**SECTION 00 91 01
ADDENDUM NUMBER 1**

**PROJECT: FIRE STATION #5 - EMERGENCY GENERATOR
730 HILL AVENUE
AURORA, IL 60505**

PROJECT NO: 19-130-1235

2.01 DRAWING E310 - ELECTRICAL FLOOR PLANS AND DETAILS

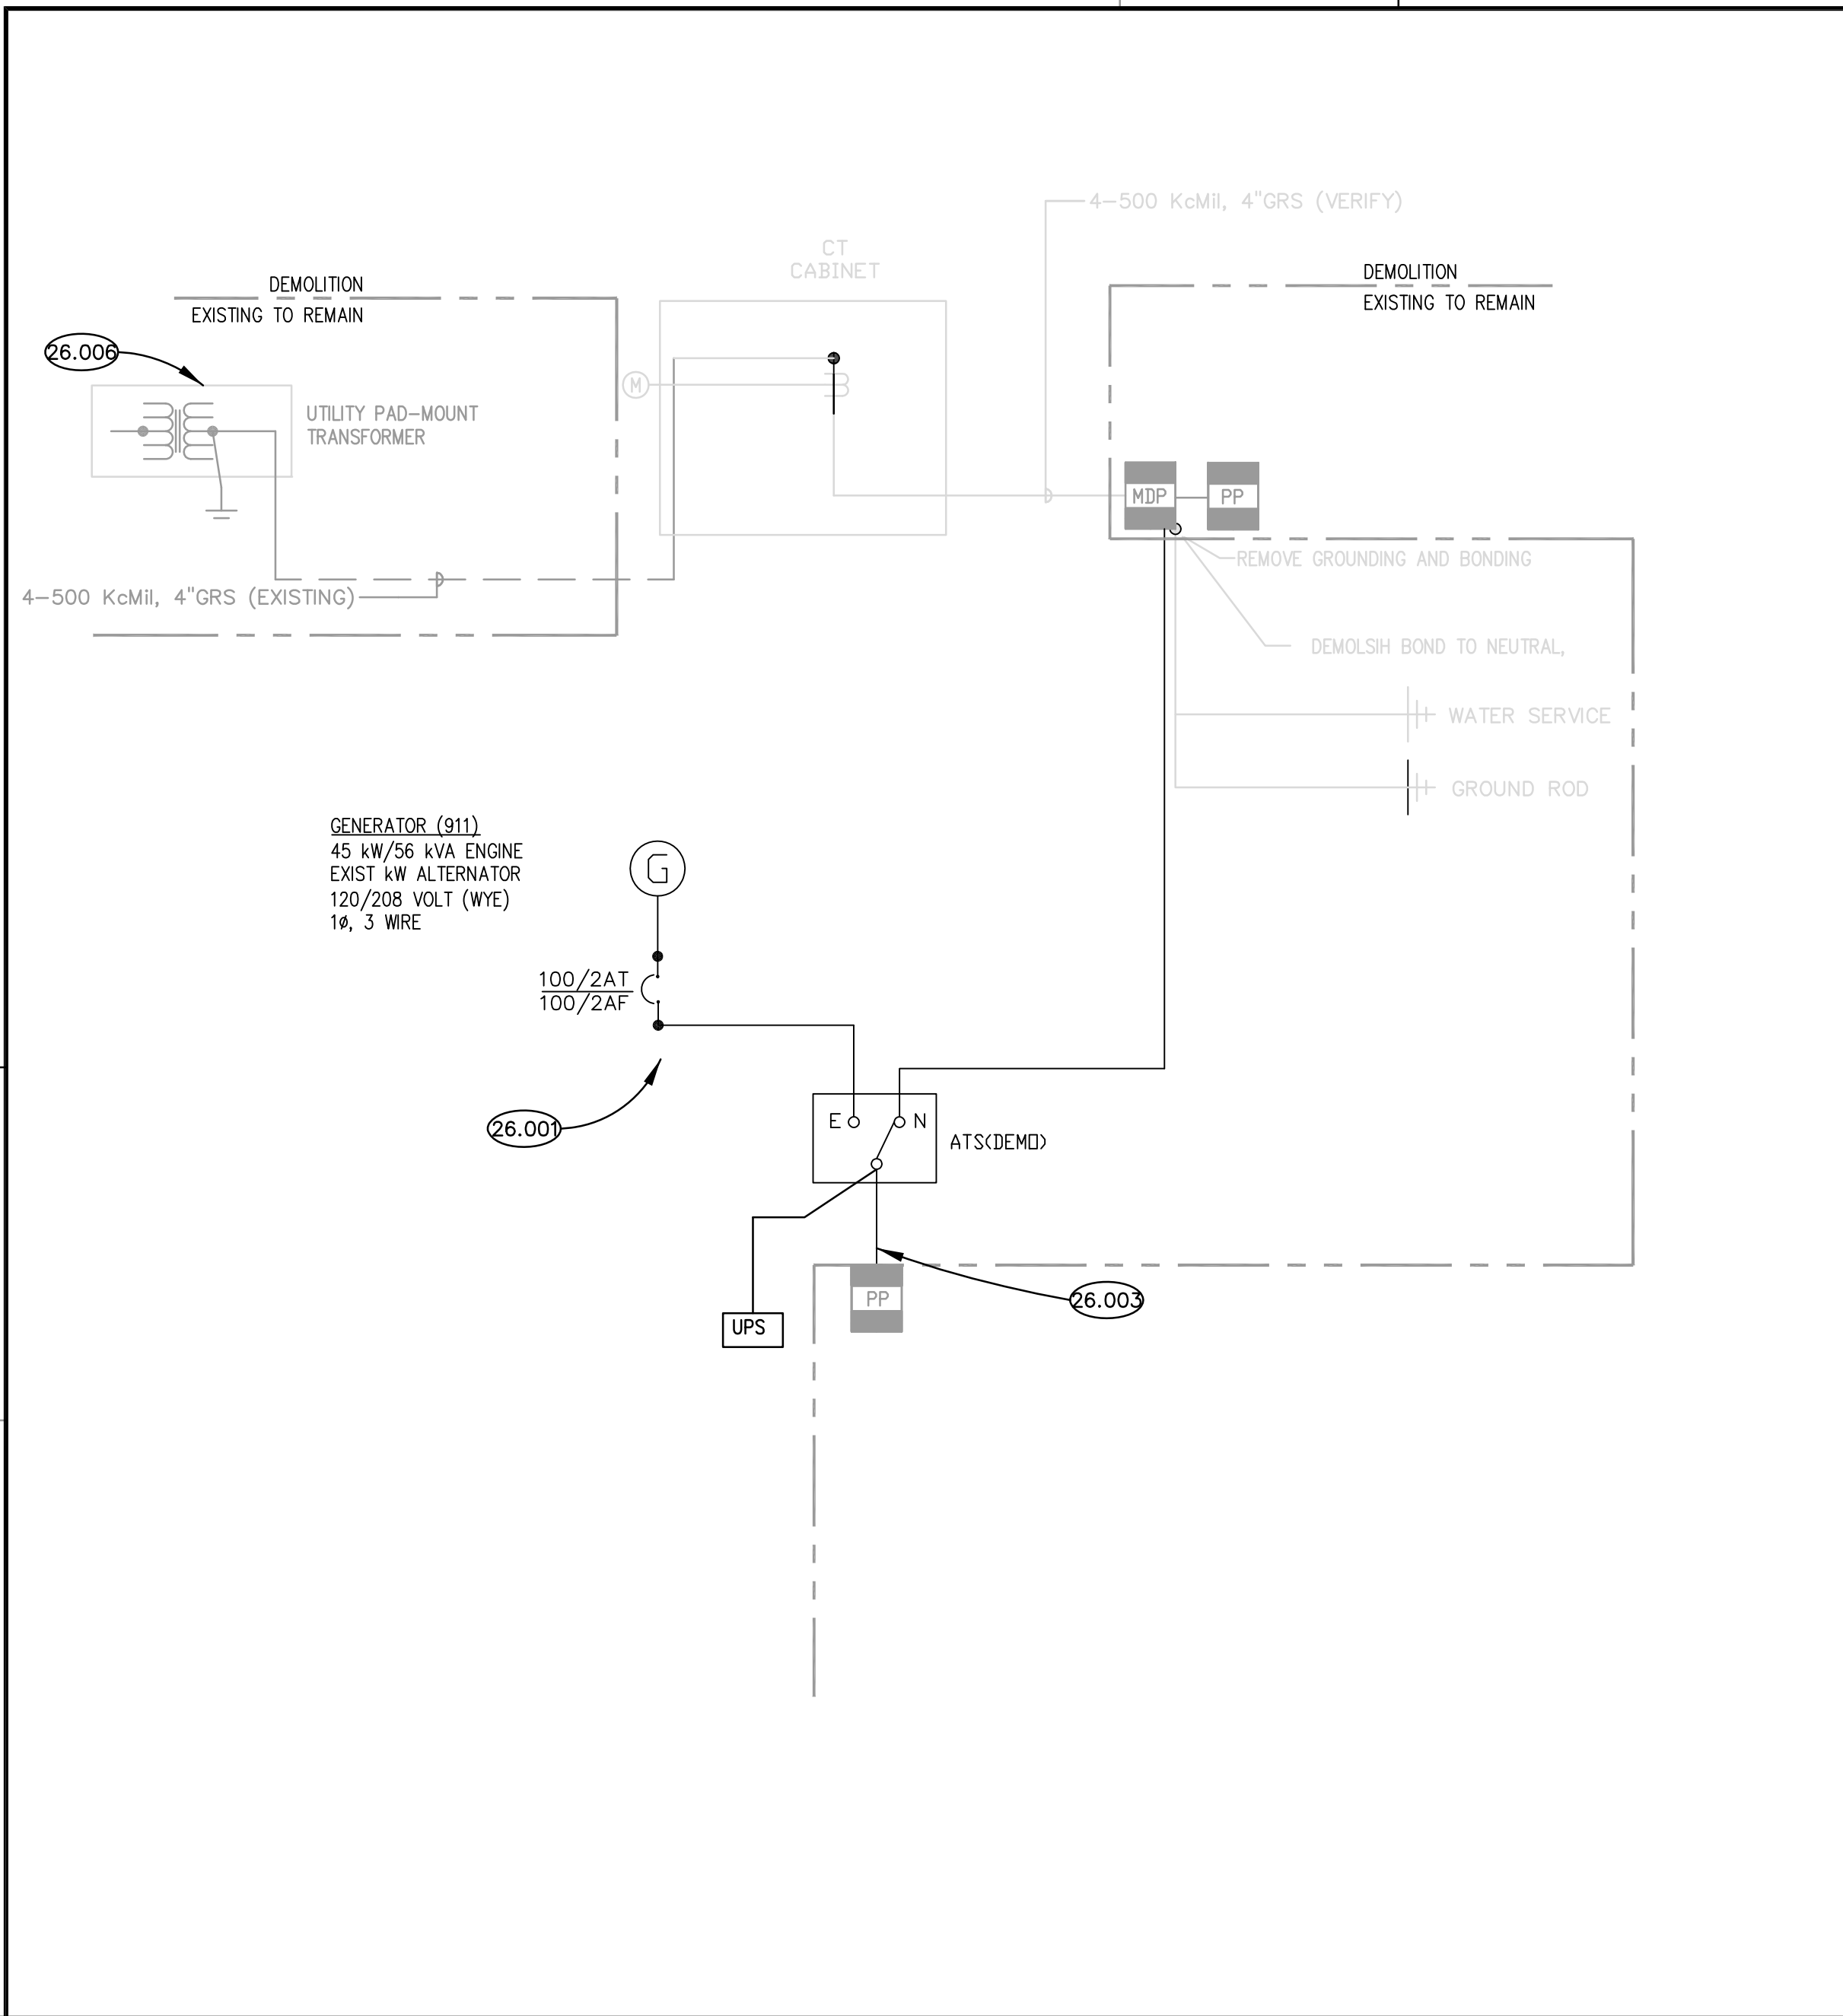
A. Contractor can provide either new cast-in-place or precast slab if they feel the "slab-jacking" approach is not the best option. We have updated Sheet E310 (attached) to reflect this option.

3.13 Keynotes 3.082 and 26.006. With ComEd removing and resetting the existing transformer, does the repair of the transformer pad/slab have to comply with ComEd standards? If not ComEd standards, to what standards shall apply for the repair of the existing transformer pad/slab?

A. See updated Sheet E310 (attached).

SHEET TITLE
ELECTRICAL ONE LINE DIAGRAM, AND PANEL SCHEDULES

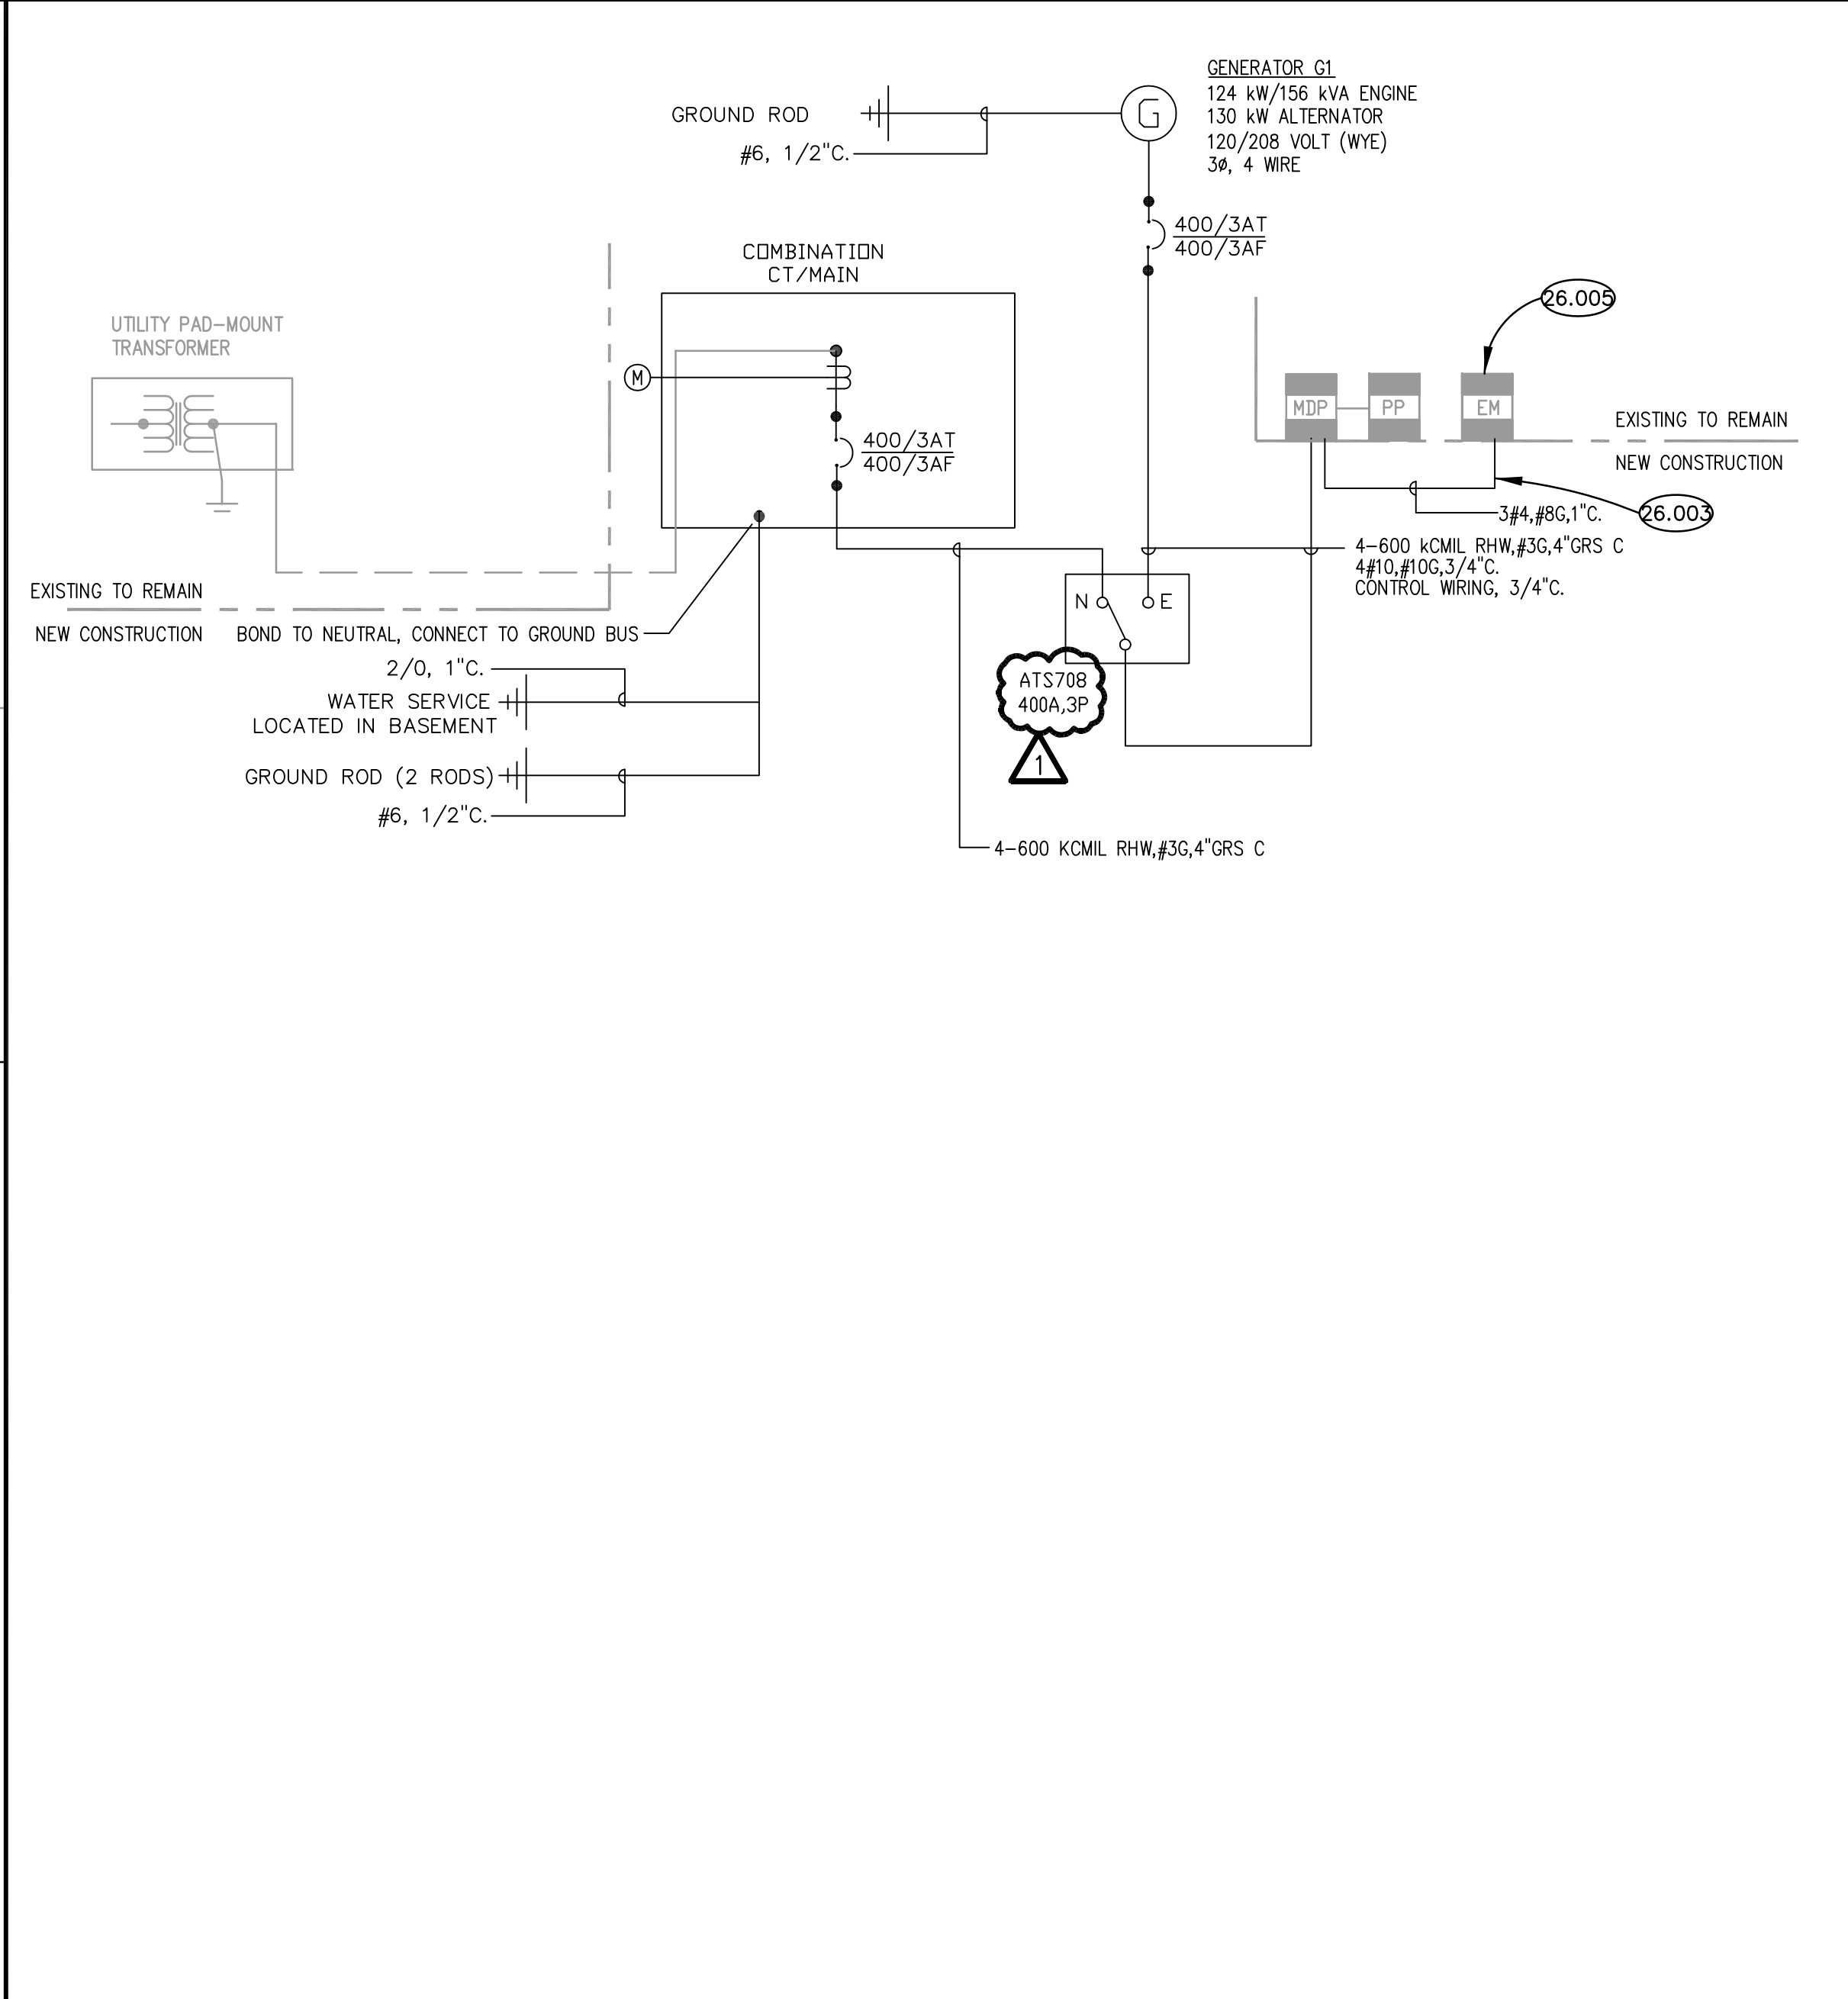
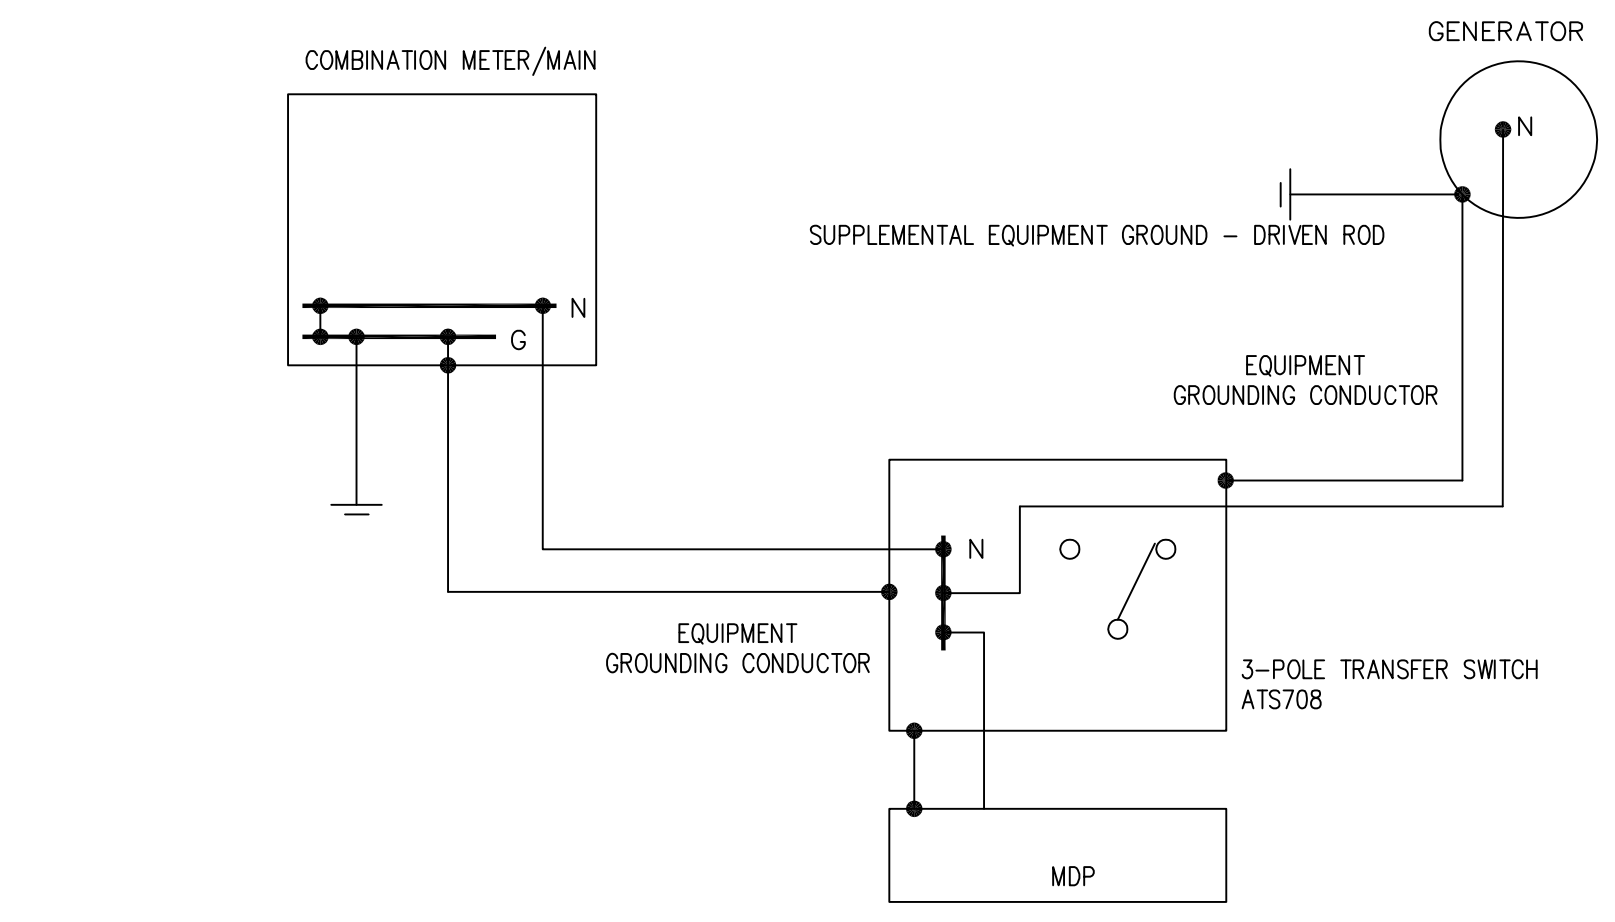
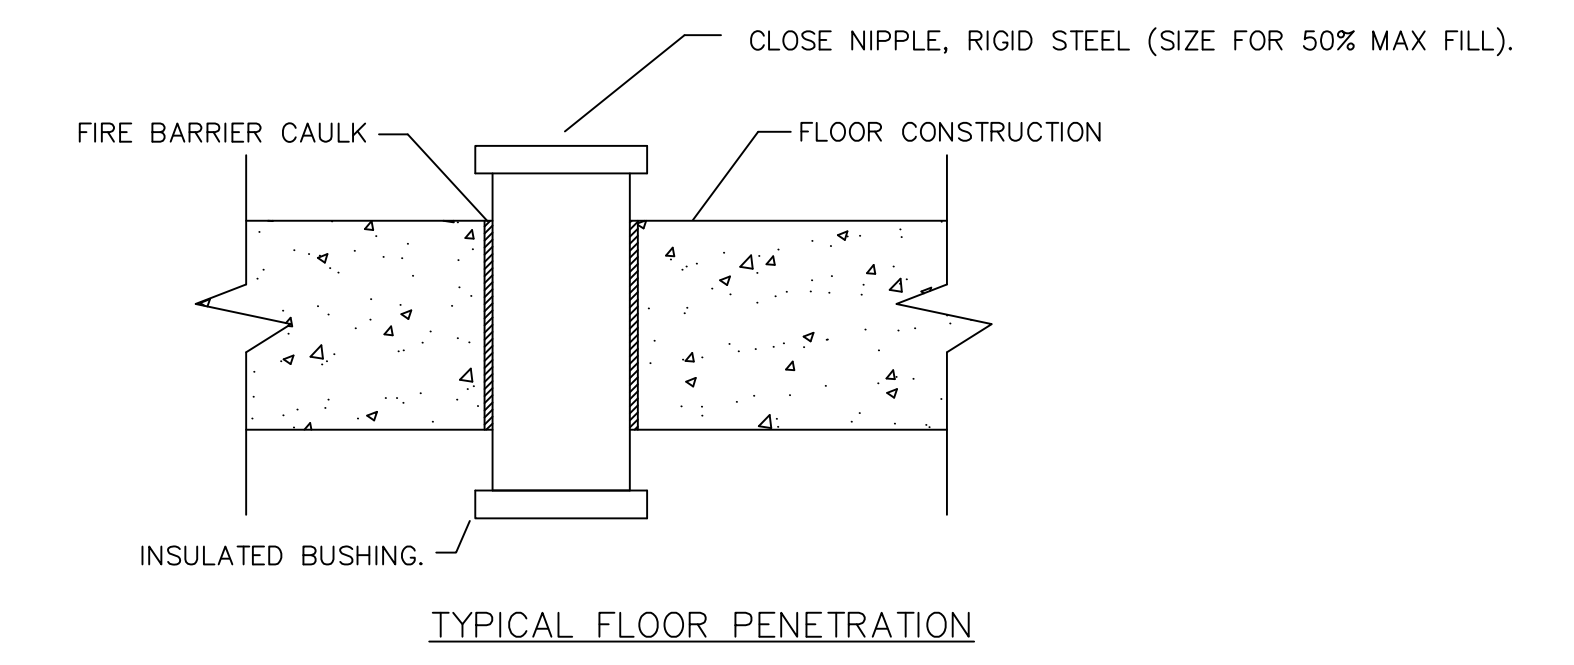
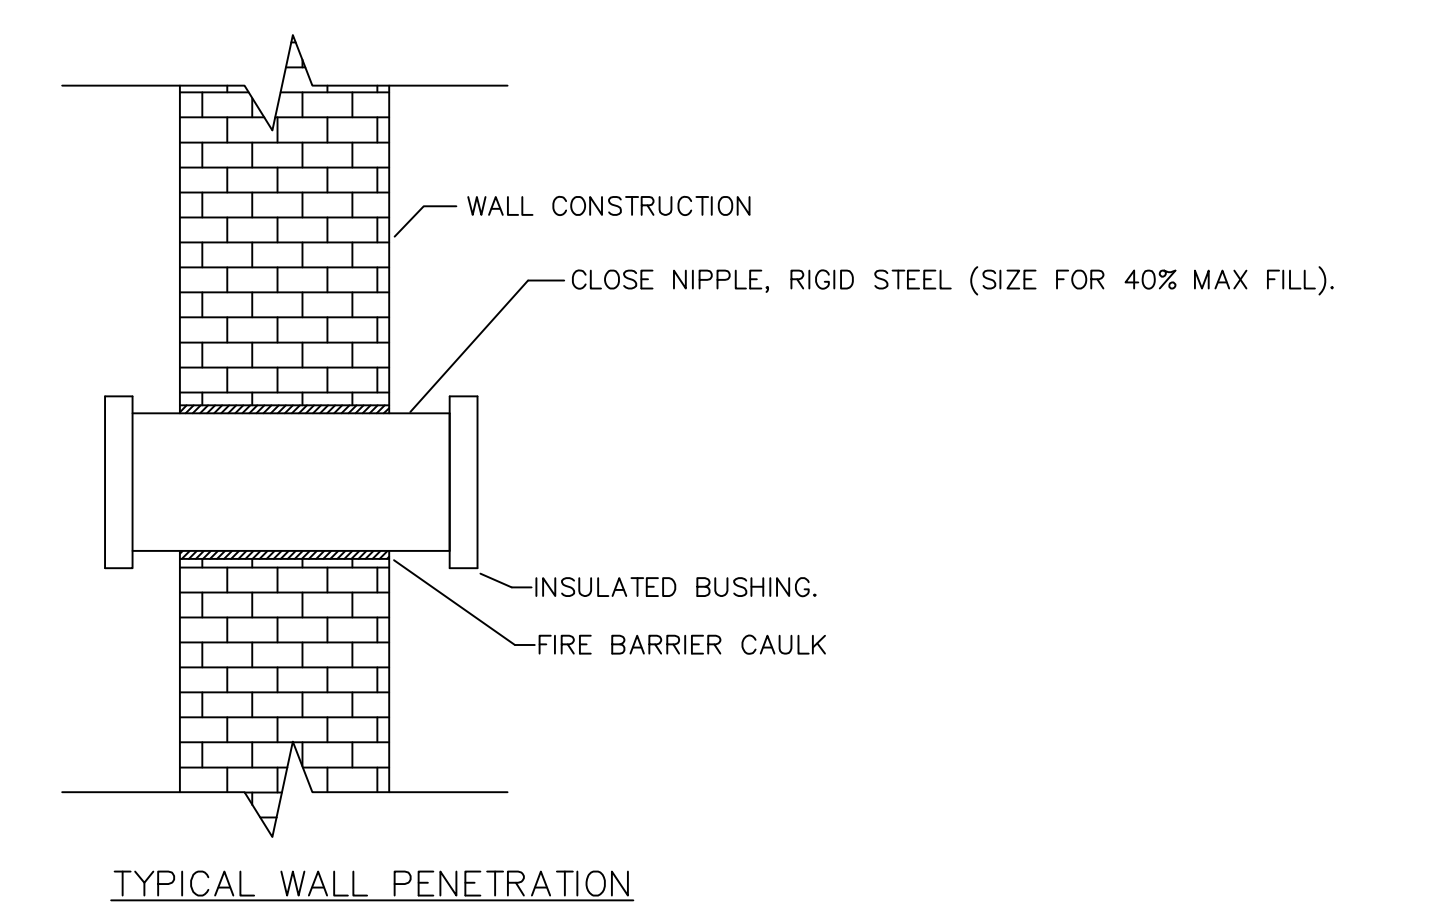
2.02 DRAWING E610 - ELECTRICAL ONE LINE DIAGRAM AND PANEL SCHEDULES

A. Delete this drawing in its entirety and replace with revised Drawing E610 attached. Refer to Revision 1 Cloud Items.
